Sumter County, Florida

A.D.A. Compliance Assessment Survey Report

100% Final
March 5, 2012

**SUMTER COUNTY
FACILITIES**

AREA: MISCELLANEOUS

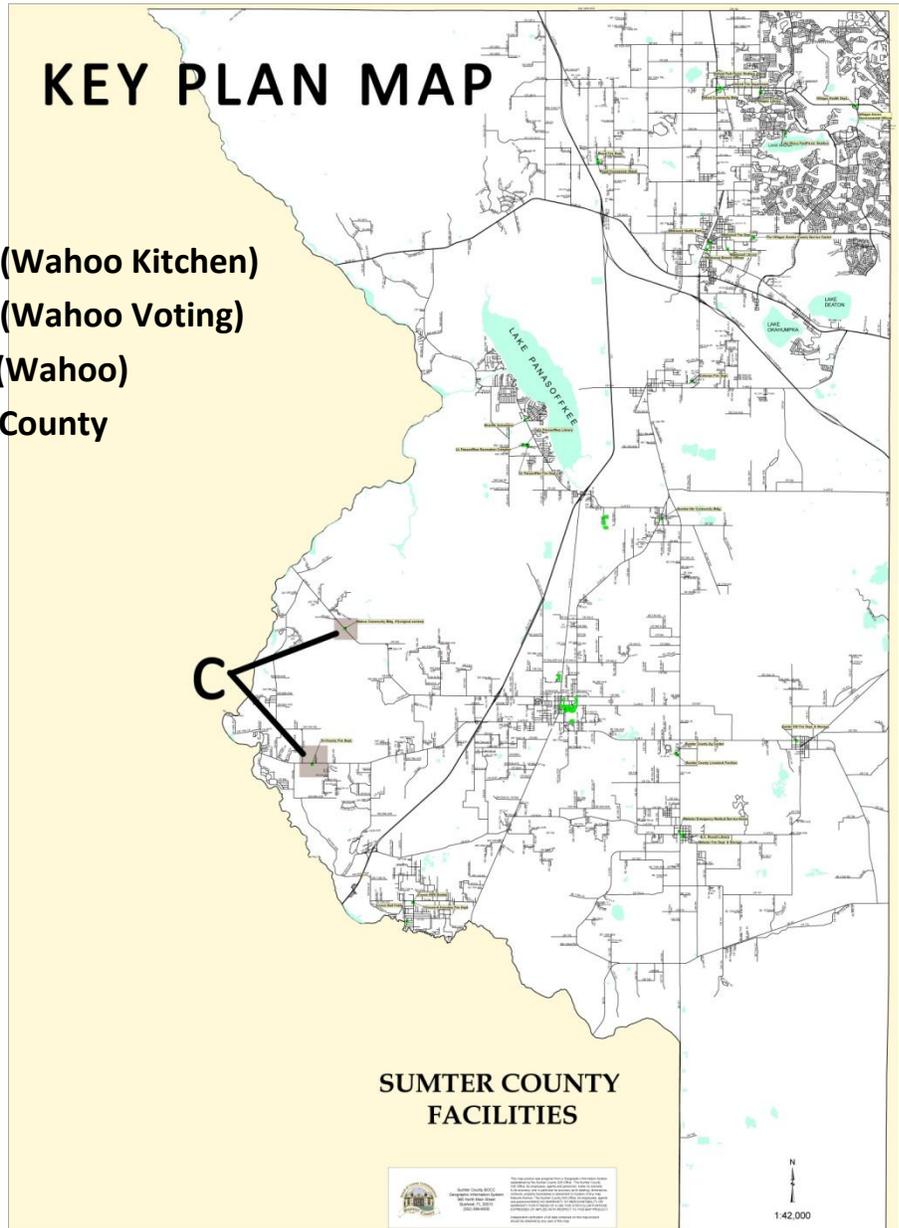
1. THERMOSTAT CONTROLS ARE LOCATED AT 55" ABOVE THE FLOOR [FBC 11-4.2.6 & 11-4.27.3] **3**
2. KEY RACK IS MOUNTED AT 72" ABOVE THE FLOOR [FBC 11-4.2.6 & 11-4.27.3] **2**

AREA: MISCELLANEOUS

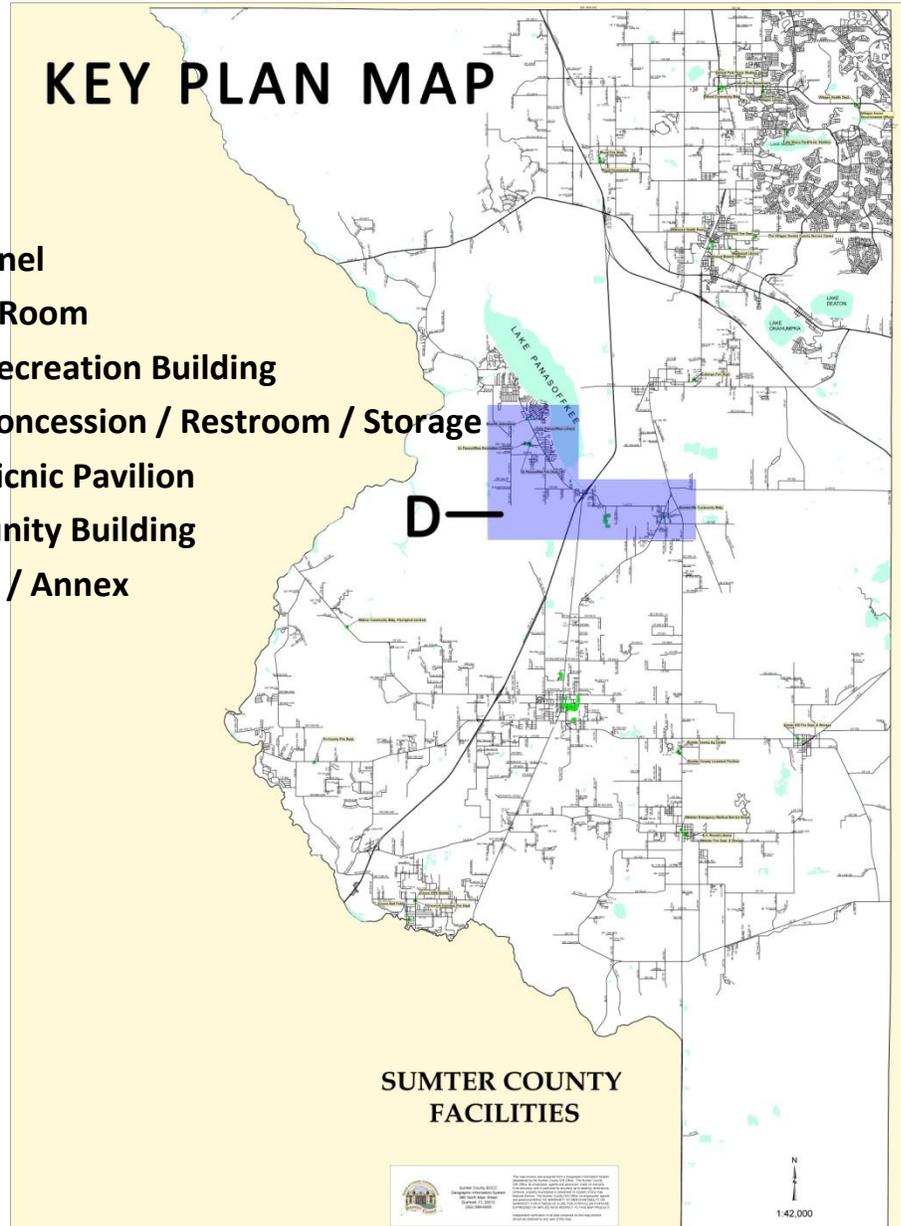
1. ALL DOOR HANDLES HAVE A KNOB DESIGN [FBC 11-4.13.9] **2**

AREA: MISCELLANEOUS

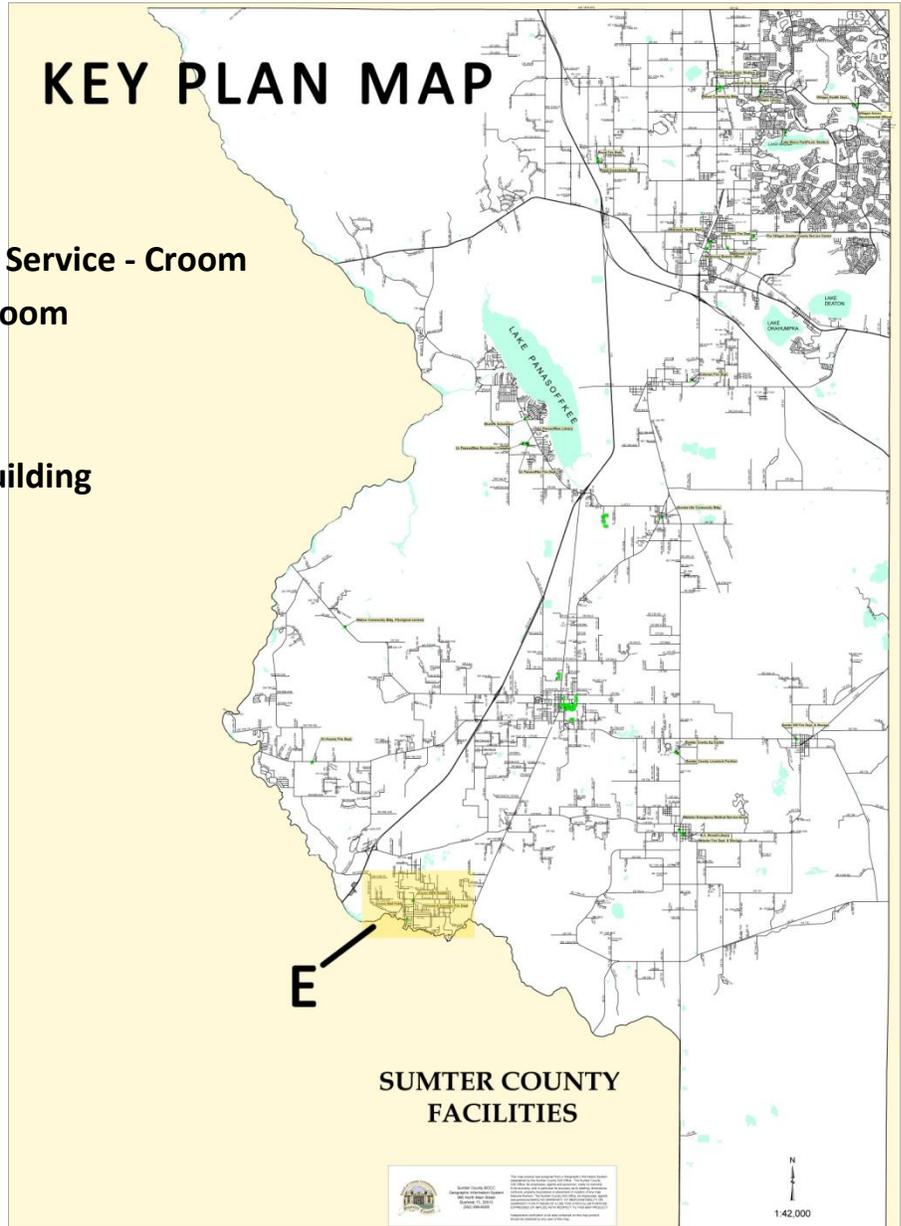
1. ALL INTERIOR DOOR HANDLES HAVE A KNOB DESIGN [FBC 11-4.13.9] **2**
2. ELECTRICAL & COMMUNICATION SYSTEM RECEPTACLES ARE LOCATED LESS THAN 15" ABOVE THE FLOOR [FBC 11-4.27.3] **3**

AREA: WEST SIDE TOILET ROOM

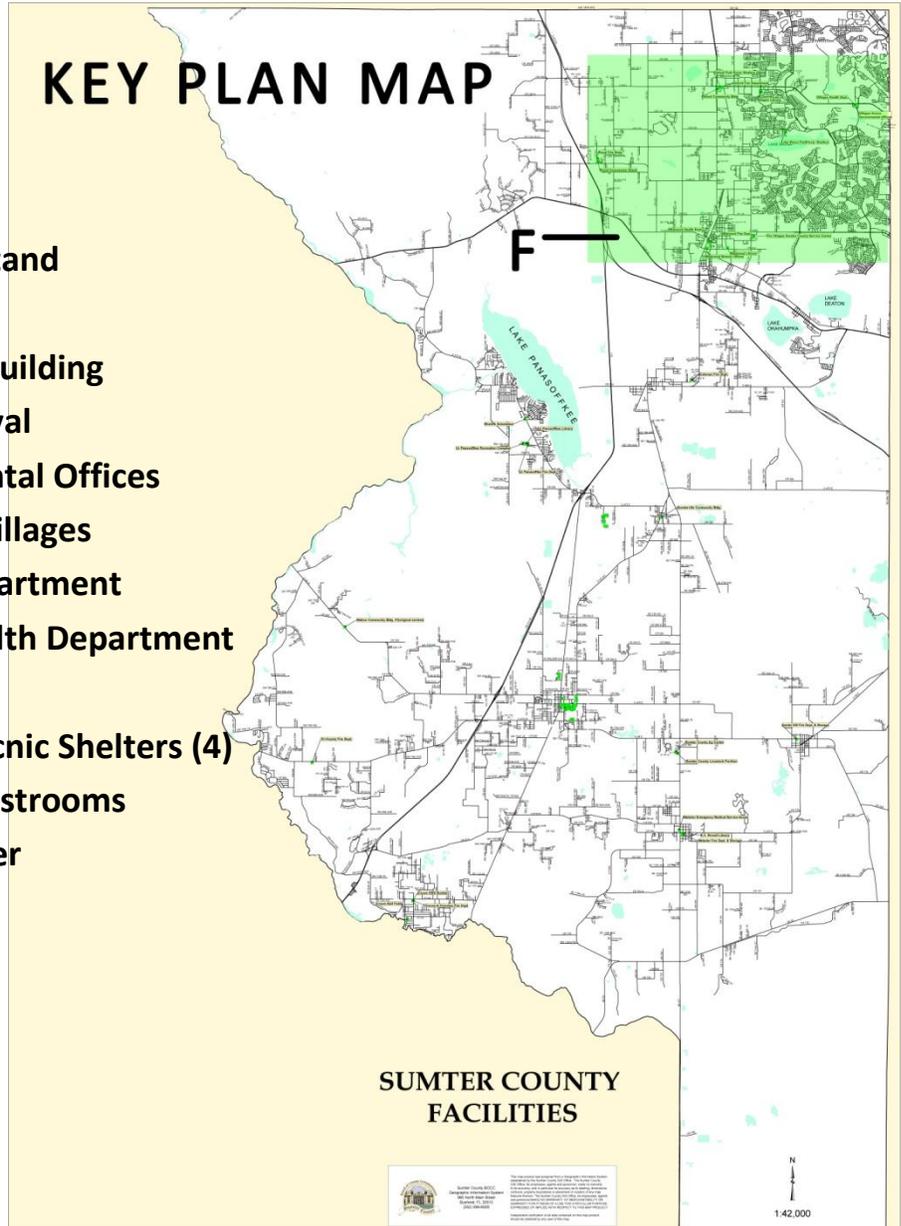
- 1. SIGNAGE [FBC 11-4.30.1] 2
- 2. REAR GRAB BAR HAS 6" FROM THE CENTERLINE OF THE WATER CLOSET TO ONE OF THE BAR ENDS [FBC 11-4.16.4] 2
- 3. WATER CLOSET FLUSH CONTROL IS NOT LOCATED ON THE WIDE SIDE OF THE TOILET AREA [FBC 11-4.16.5] 3
- 4. LAVATORY RIM HEIGHT IS 34.5" ABOVE THE FLOOR [FBC 11-4.19.2] 3
- 5. LAVATORY SELF-CLOSING VALVE CLOSES AFTER OPERATING FOR 4 SECONDS [FBC 11-4.19.5] 2
- 6. PAPER TOWEL DISPENSER LEVER IS MOUNTED AT 58" ABOVE THE FLOOR [FBC 11-4.2.5 & 11-4.27.3] 2
